Subject: Transmittal of Class 1 Permit Modification to Update Figures in the Los Alamos National Laboratory (LANL) Hazardous Waste Facility Permit, EPA ID No. NM0890010515

**CLASS 1 PERMIT MODIFICATION NOTIFICATION
STRUCTURE CHANGES AT TECHNICAL AREA 54**

ENV-DO-14-0023

LAUR-13-29257

Figure 37: Technical Area (TA) 54 West, Building 38 Indoor (High Bay and Low Bay) and Outdoor Pad

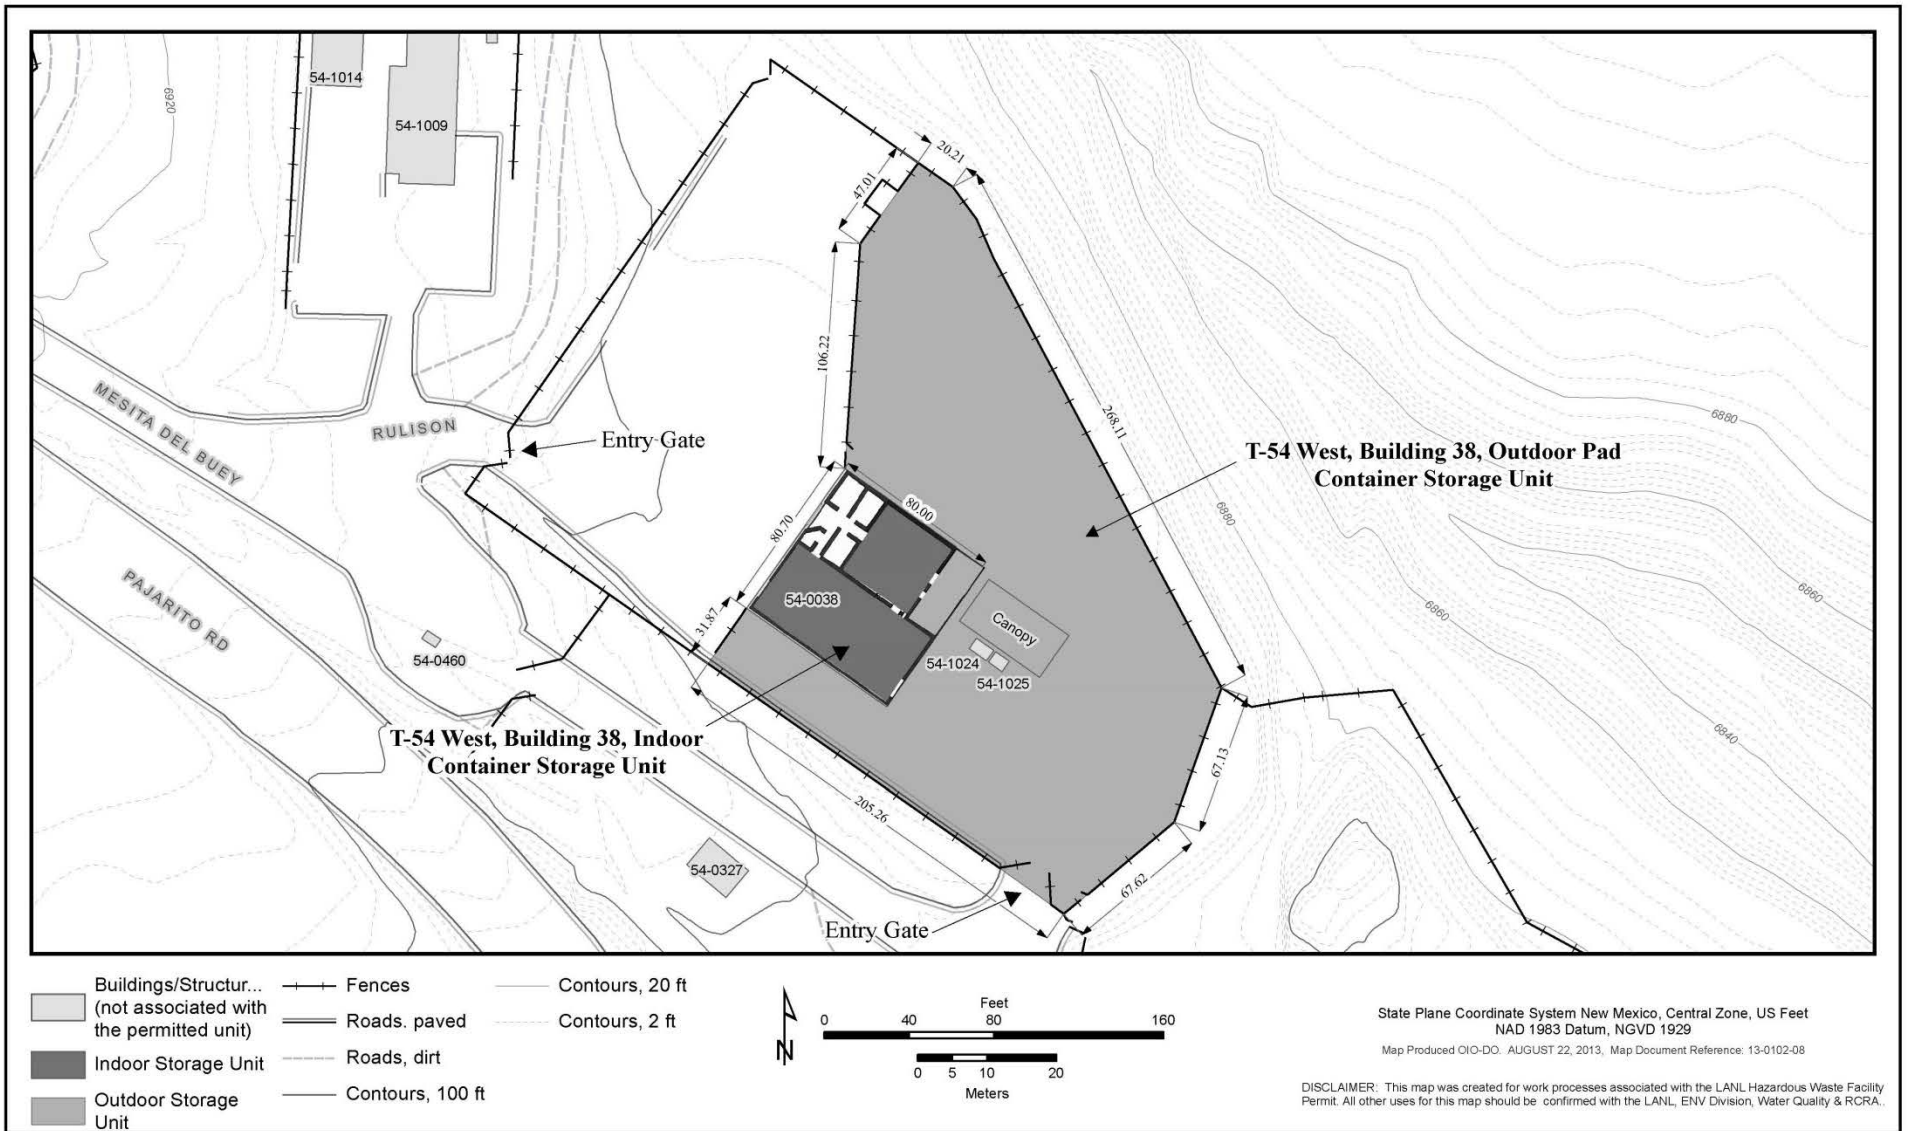
Figure 9 (Technical Area (TA) 54 West Location Map Showing Security Fences, Entry Gates and Entry Stations) and Figure 37 (Technical Area (TA) 54 West, Building 38 Indoor (High Bay and Low Bay) and Outdoor Pad) were revised to remove Structure 54-34 and to make the fence line continuous. Structure 54-34 previously served as part of the fence line boundary for the permitted unit. The structure was removed and the fence around the unit was completed to demarcate the boundary of the permitted unit.
